DESIGN REVIEW COMMISSION STAFF REPORT

MEETING: July 6, 2016

SUBJECT: **New Hotel at Wood Hollow**
Design Review Workshop #1
File: P2015-091; Design Review
APN 125-202-13 and -14; 7701 Redwood Blvd.

NOVATO HYATT HOUSE
PRELIMINARY GRADING & DRAINAGE PLAN

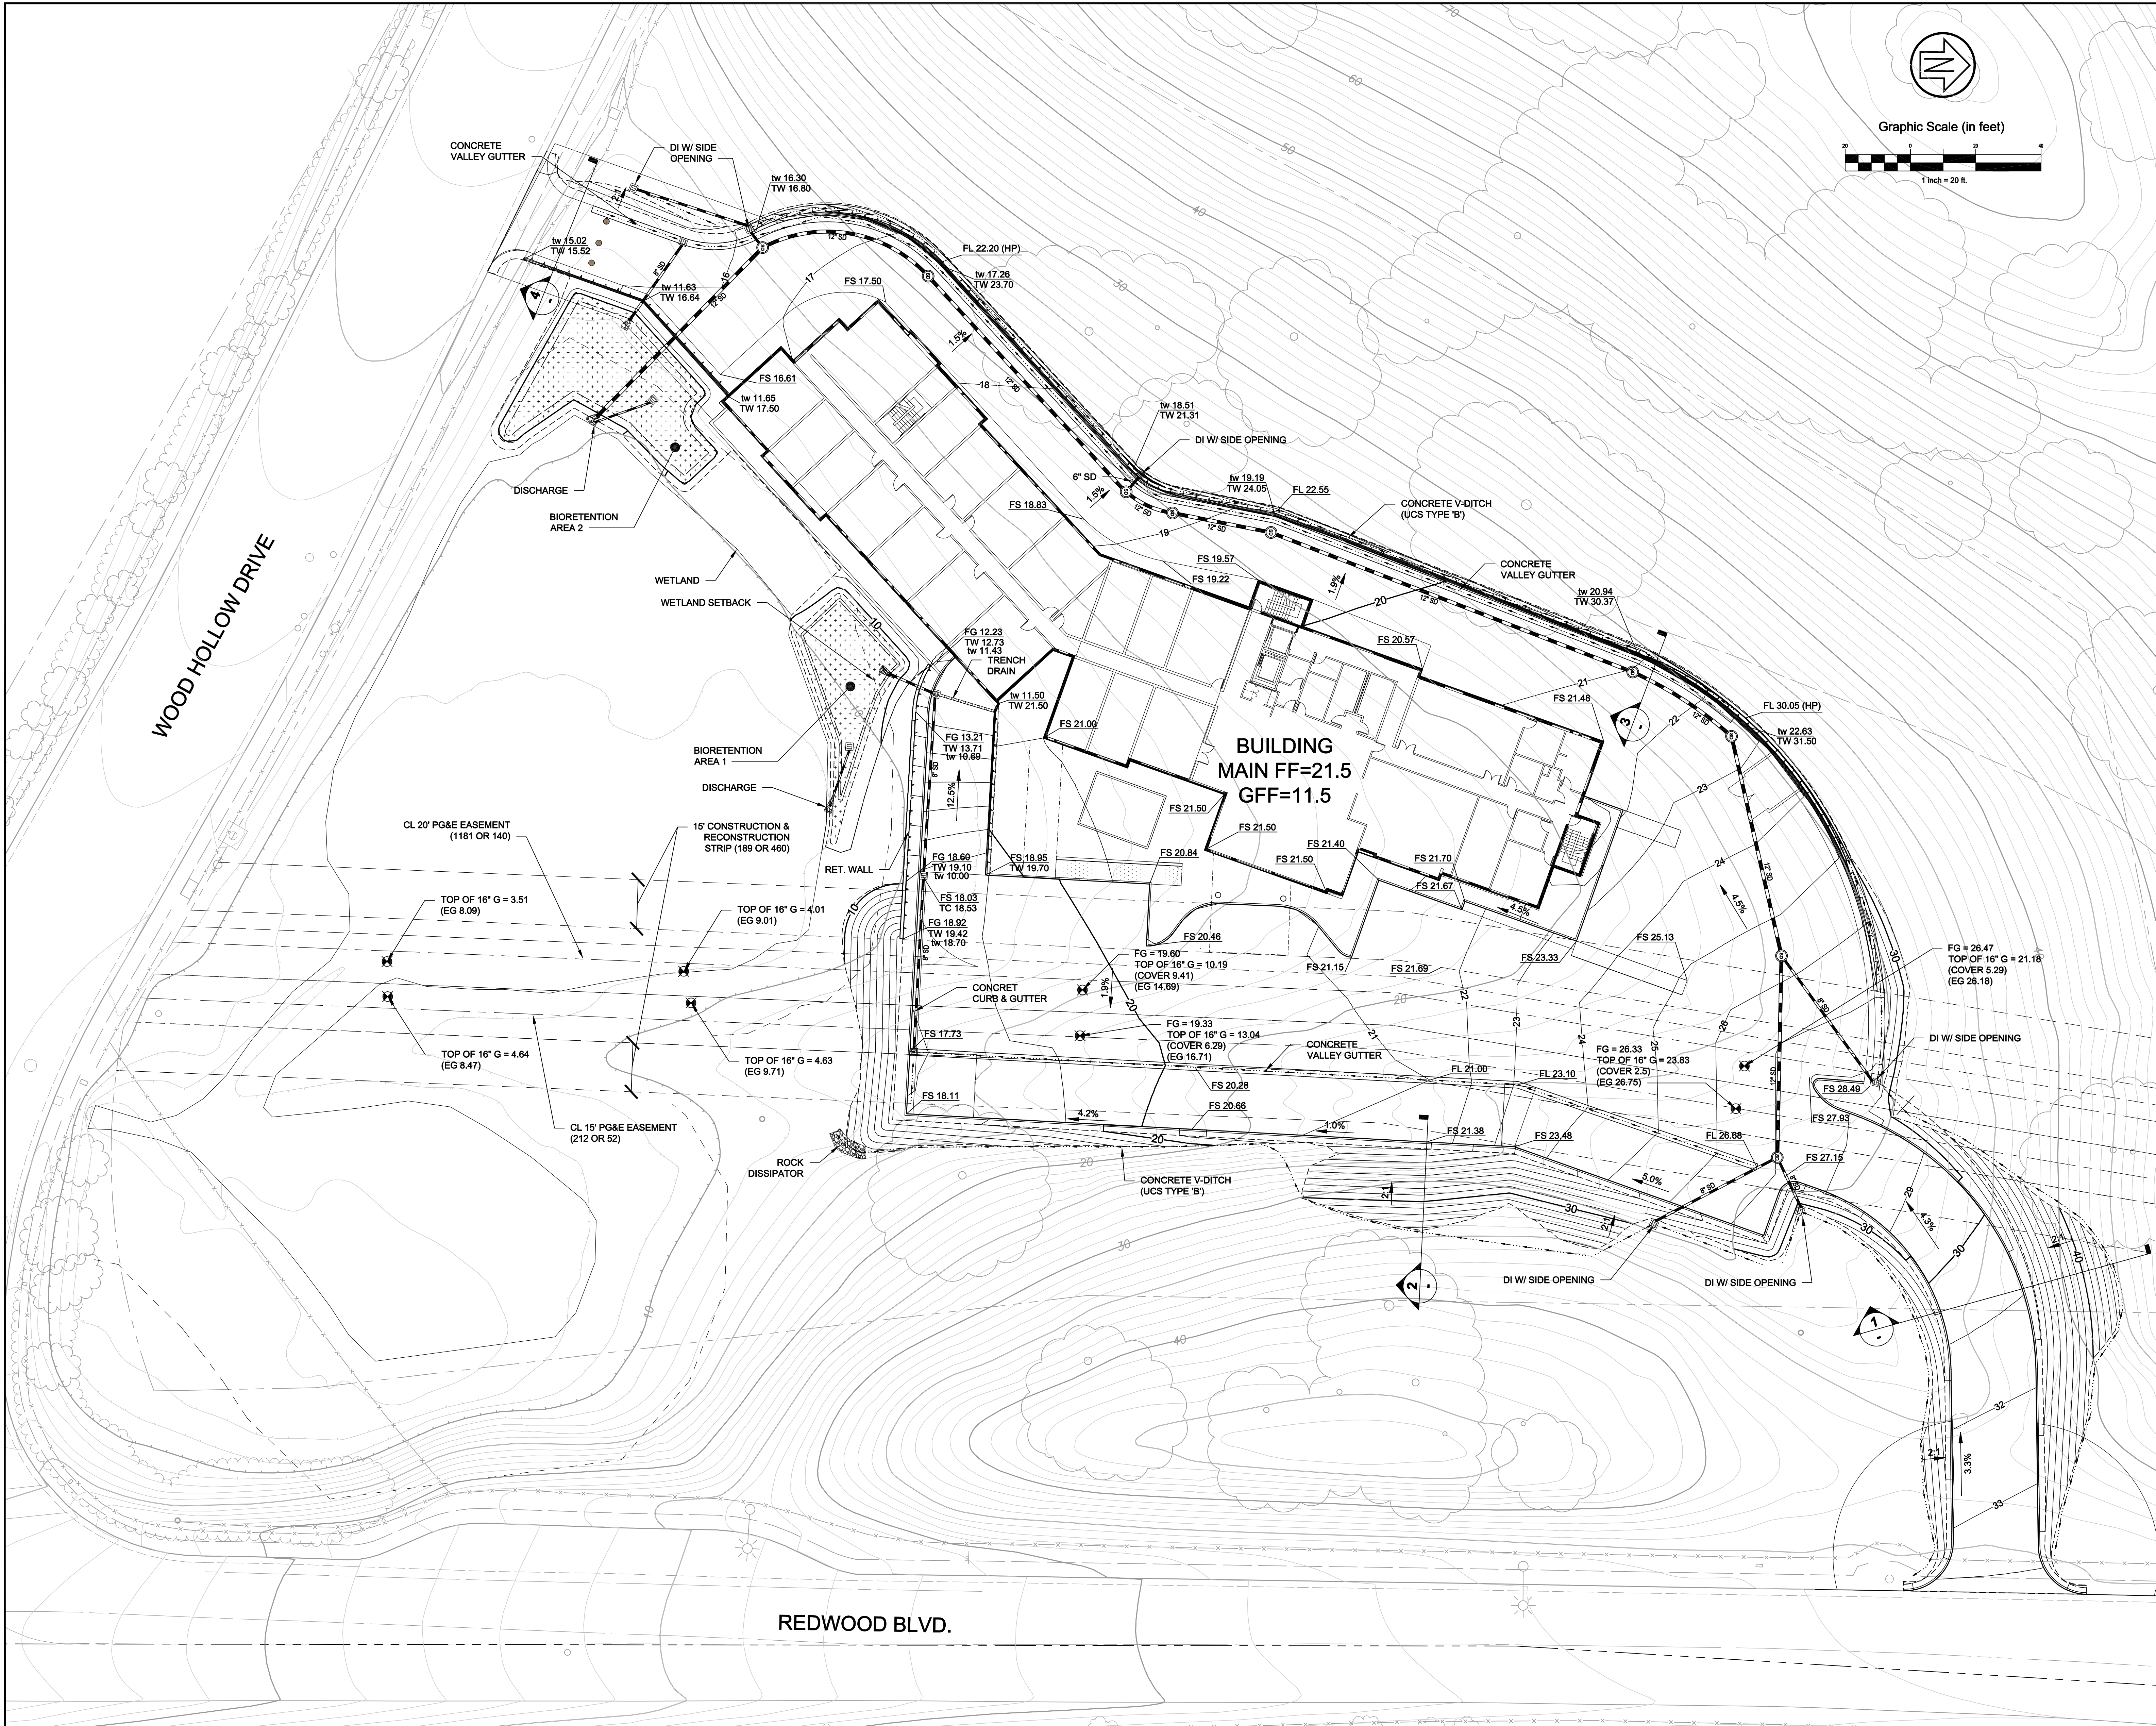
To evaluate the issue of the wetland setback for the proposed hotel, we reviewed the Preliminary Grading and Drainage Plan for the project prepared by CSW Stuber-Stroeh Engineering Group, Inc. dated April 26, 2016 (05/05/16 submittal; 06/14/16 Amended Site Plan & Grading); an exhibit entitled San Marin Business Park, Hydrology Map dated December 19, 2012, and also prepared by CSW Stuber-Stroeh Engineering Group, Inc.; our own files on the original (1999) wetland delineation for the San Marin Business Park site; and other available documents related to the proposed hotel site. In addition we consulted with the project engineers (CSW ST²) and visited the site on November 12, 2015, and again on June 29, 2016.

The proposed hotel would not encroach into the delineated wetlands, but would modify the existing hydrology of the site. Most of the natural runoff from the hillsides above the hotel and parking areas would be collected in a perimeter concrete v-ditch above these site improvements and routed via a 12-inch storm drain line into the adjacent wetlands.¹ The discharge for this background runoff would be located at the westerly end (upper sub basin) of the delineated wetlands. Runoff collected from the improved areas of the site would be routed through two bio-retention areas where it would percolate through filtration media before discharge into an underdrain system. High flows that fill the bio-retention areas during major storm events would overflow into the adjacent wetland areas.

The bio-retention areas would be located directly adjacent to the delineated wetlands but all other elements of the project, except for an approximately 200 square foot area of fill within 10 feet of the wetland perimeter, would be located 20 feet from the wetland boundary. As noted above, the bio-retention areas would be allowable within the wetland buffer zone and could potentially be designed to function as an enhancement to the adjacent seasonal wetlands.

Whether the hotel, parking and small area of fill were set back 10, 20 or 50 feet from the delineated wetlands would not substantially change the project’s effects on the wetlands. The functions and values of the wetlands on the site, especially the westerly of two delineated sub basin areas, are not high. They are isolated, seasonally wet areas, heavily used by cattle in the past and dominated by mostly non-native hydrophytes. The wetland characteristics of the westerly of the two sub basins (where the buffer reduction would primarily apply) are far less pronounced than those in the lower (easterly) sub basin and merge more or less seamlessly with the upland grassland habitat characteristics of the adjacent hillside.² The issue with preserving and even possibly enhancing the wetlands on the

Based on our initial review and discussion with CSW ST² (Wayne Leach, telephone conversation, 6/28/16), we believe that the drainage plan for the project as described above would preserve the hydrological characteristics of the delineated wetlands on the site and even possibly enhance them. The discharge location for the background (hillside above the project) runoff would be located in what is now a drier part of the delineated wetland area, possibly increasing wetland characteristics in that area. Rather than an energy dissipator at that location, an infiltration gallery might disperse those background flows over a wider area. The bio-retention areas could also be designed with overflow weirs instead of discharge points into the wetlands and the subdrains beneath them could also be routed accordingly.
